Extraordinary Meeting of Council Meeting 11 May 2020
ST LEONARDS SOUTH UPDATE – DESIGN CHARRETTE RESPONSE

Subject: St Leonards South Update – Design Charrette Response
Record No: SU5943 – 20967/20
Division: Environmental Services Division
Author(s): Christopher Pelcz; Terry Tredrea; Lara Fusco

Figure 5b: Cross section of proposed streetscape scale

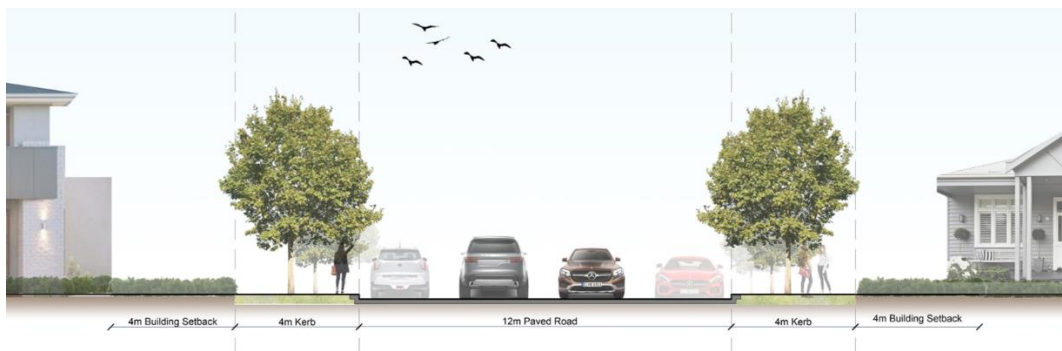
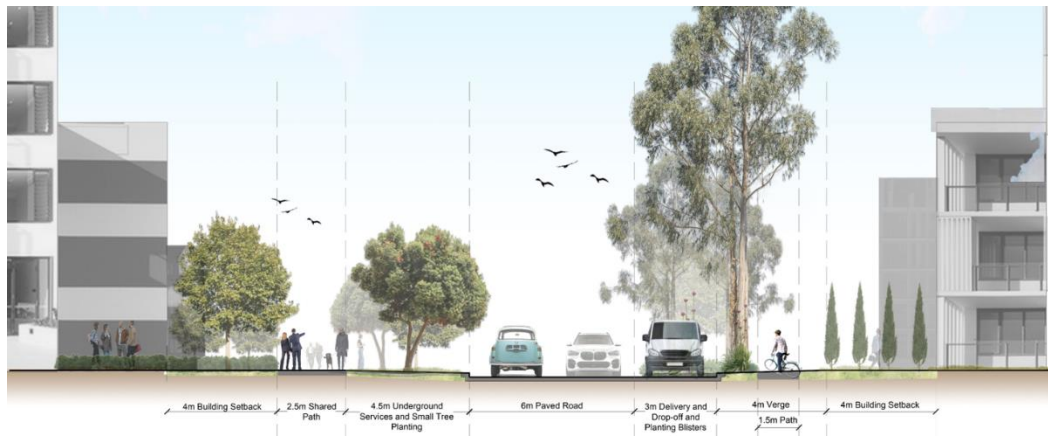
In response to the IPC seeking “...notably improved connections to existing surrounding open spaces” (para 127), and the Charrette’s recommendation to “improve permeability and safe movement within and through the site”, **redesign to parts of the north-south street parking, as shown below in Figures 5a and b, are recommended which create wider, green verges to provide for safer pedestrian and cycling movement, undergrounding of services and increase canopy cover.**

Figures 5a and b above shows Before and After sections of a typical north-south street. The right-hand side of parking is partly replaced by blisters containing trees and delivery/drop-off areas. The left side of the road expands the verge by an extra 3 metres to be planted, incorporate shared pedestrian/bicycle pathways and contains undergrounded services (including power lines).

The recommended measures to improve the streetscape (Figure 5b) would reduce the availability of on-street parking and it is therefore recommended that DCP Parking Rates be informed by future investigations. However, this would not delay the finalisation of the LEP.

Figure 6 – Proposed East – West Pedestrian Connection

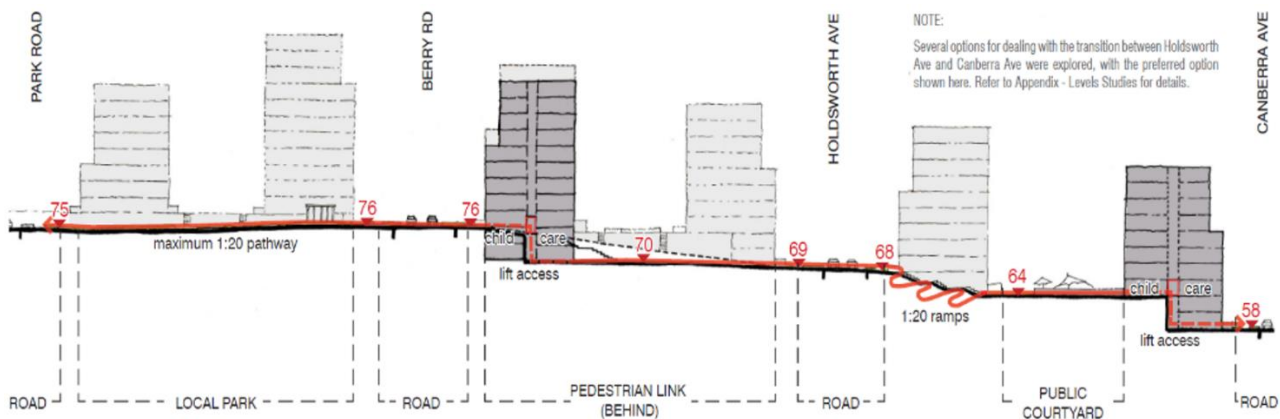
The Charrette’s six east-west links are only moved three or four lots north and widened in some cases. In effect, the walking journey to major destinations is the same, and is not improved. The Council plan focuses on pedestrian friendly and accessible links with no vehicular connections in the mid-block connection. The addition of the integrated multi-purpose facilities in buildings on Canberra Avenue and Berry Road along these connections is to further promote community interaction and connectivity. The Charrette proposal would remove Council’s coherent and accessible central east-west pedestrian and cycle only link between the two major parks.

In terms of accessibility, both the Charrette’s recommendation and Council’s design, require ramps and lifts from Canberra Avenue and Berry Road to achieve compliance with the Disability Discrimination Act. This is because the fall between Berry Road and Canberra Avenue is 18 metres, (6 storeys), which is illustrated in Figure 6.

Figure 7: Shadow Modelling of Council's Proposal and Design Charrette Proposal

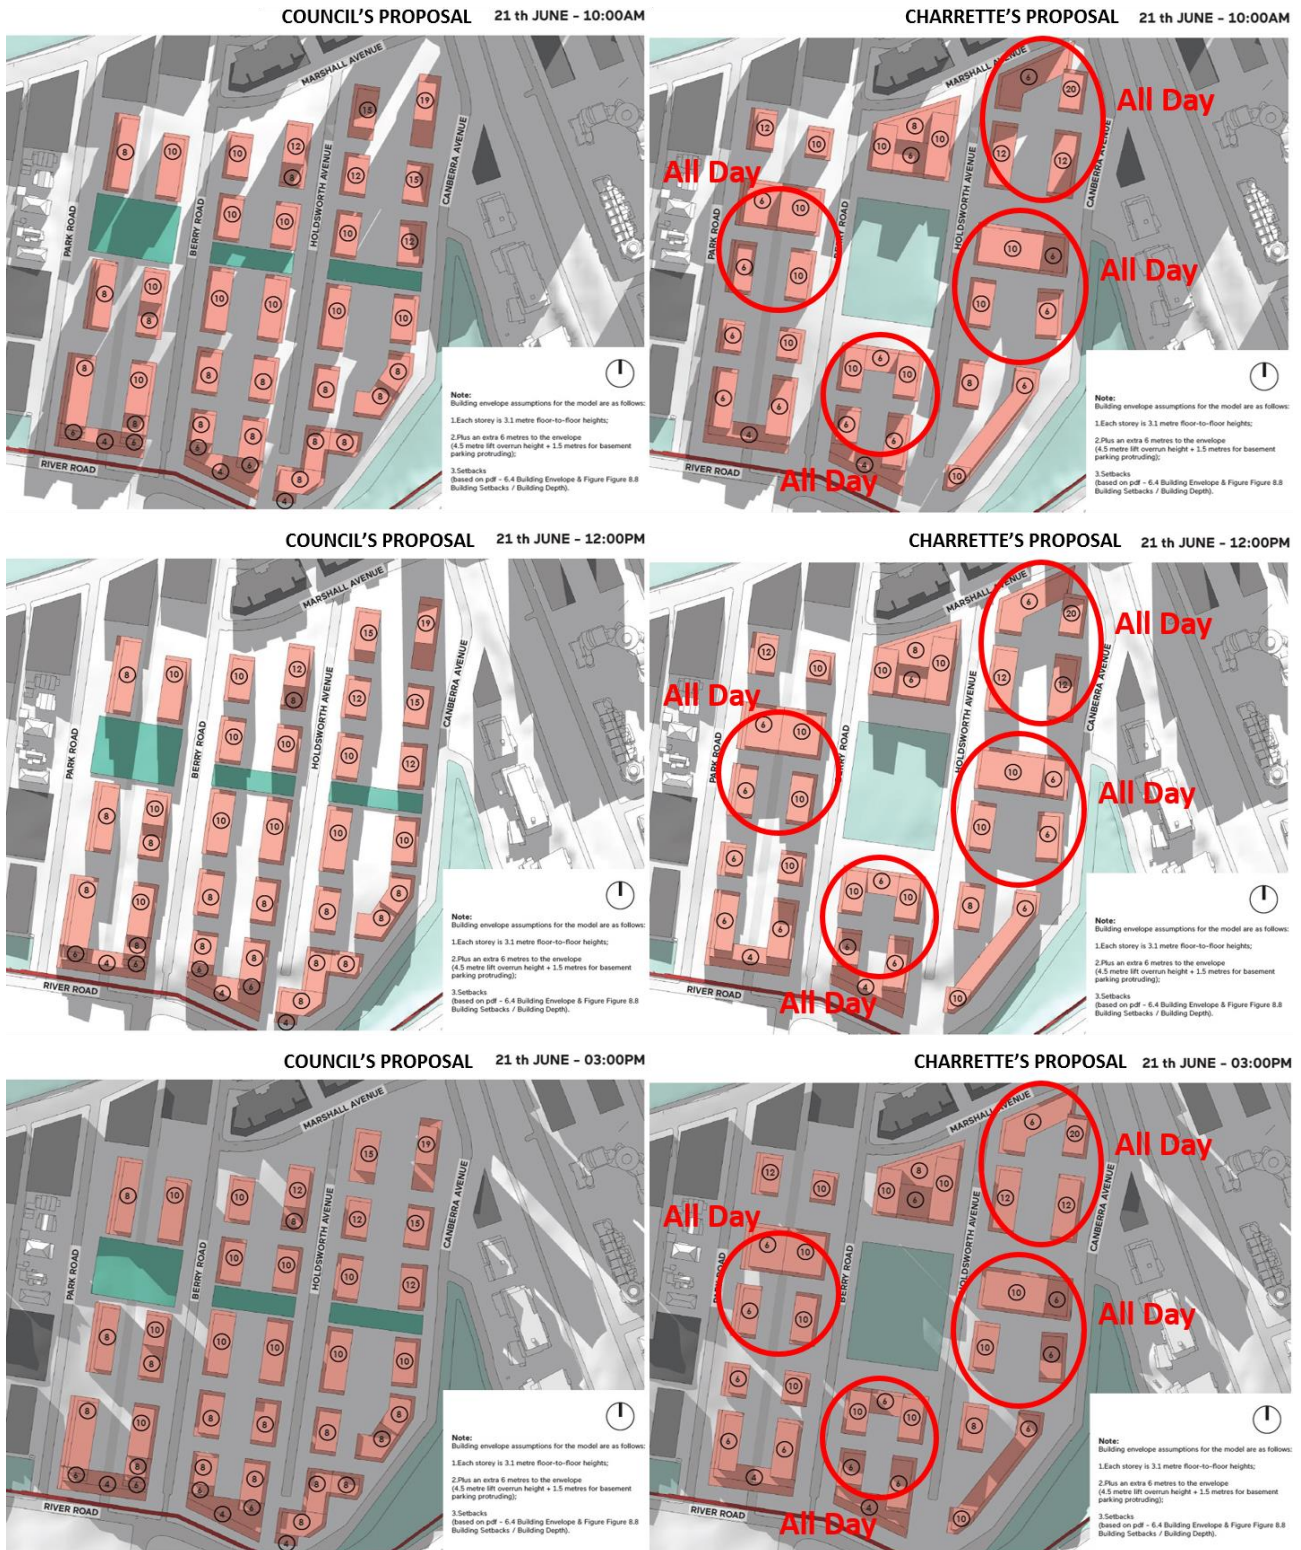
The proposed layout by the Charrette locates buildings across the proposed 'Green Spines' in five places. This would dramatically reduce solar access (and cross ventilation) in these areas and would be inconsistent with the State Government's Apartment Design Guidelines (ADG) to deliver a minimum of 2 hours solar access. This is demonstrated in Figure 7 below. Buildings in the precinct at medium - higher levels have views southward towards the harbour, which delivers enhanced amenity. The inclusion of East – West buildings blocks these views, which is undesirable.

Consolidating social infrastructure around the Charette's proposed open space is unlikely to be viable if these buildings also have to provide the east-west links (north and south sides of park), while buildings to the west and east of the park have 10 storeys presumably to compensate for amalgamation with 6 storey buildings.

Figure 10 Council proposed setbacks to Park Rd (excl southern most site)

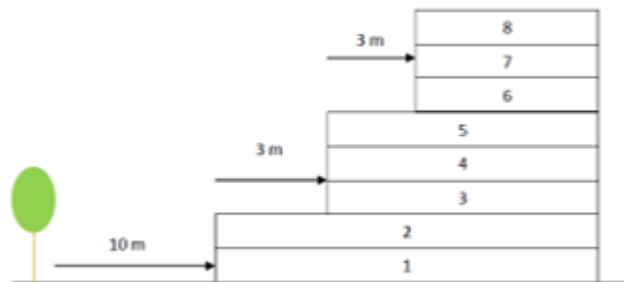
Additional Charrette Comment within Recommendation 13: Reduce setbacks in East – West transition to Park Road

for two thirds of buildings) would result in an increased visual impact compared to Council's proposal and is not supported.

The 10 metre setback is not possible on the site on the corner of Park Rd and River Rd due to the need to widen the building separation between the East and West buildings to achieve solar access compliance for the lower level apartments. For the remainder of Park Road, the separation between the proposed apartments on the eastern side and the houses on the western side is approximately 40 metres, comprising 10 metre setback for the apartments (additional 3 metres before greater than 2 storeys), 20 metre Road Reserve, and an average 10 metre setback to the houses. Park Rd also includes an extensive tree canopy, providing further visual separation.

Figure 11: Sub precincts A & B

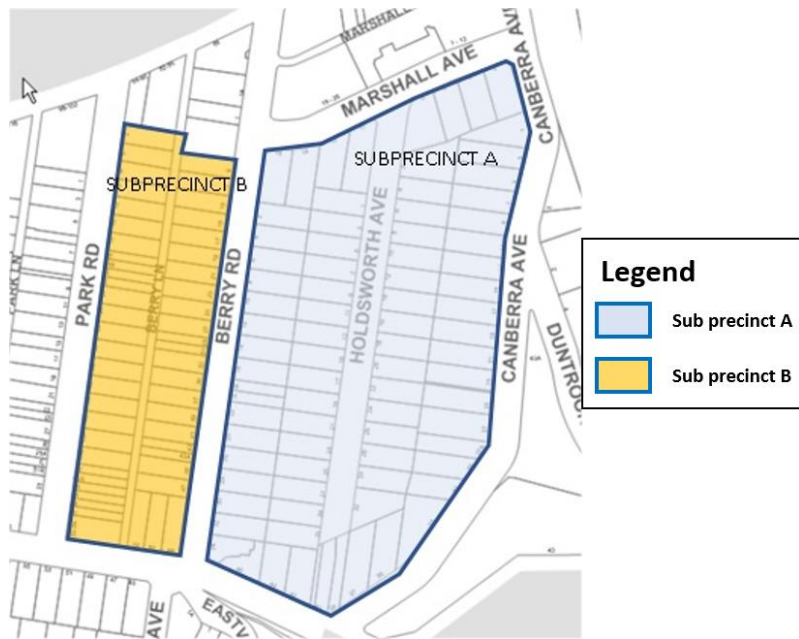
In addition, HillPDA conducted an updated feasibility analysis (**AT-6**) that reviewed options for reducing the floor space ratio (FSR) and height. It also examined what feasibility would be needed to provide Affordable/Key Worker Housing and community facilities (i.e. multi-purpose facilities). Some measures from the Charrette (i.e. parking rates and revised bedroom mix) were also included, along with Council's increased rates in its draft Section 7.11 contributions plan.

It is important to note that in the updated feasibility analysis the land between Canberra Avenue and Berry Road (east side) is identified as Sub-precinct area A and land from Berry Road (west side) to Park Road is Sub-precinct area B (Figure 11). The design of sub-precincts A and B differ because there are generally smaller lots in sub precinct B and therefore the cost of acquiring land is higher.

- The minimum viability for sub precinct A requires a minimum FSR of 2.5:1;
- The minimum viability for sub precinct B requires a minimum FSR of 2.6:1;
- Both multi-purpose facilities (child care and community halls) can be provided under the proposed bonus FSR scheme;
- The minimum viability needed for Key Worker housing is 3:1, and with a revised bedroom mix, more Key Worker dwellings can be achieved.
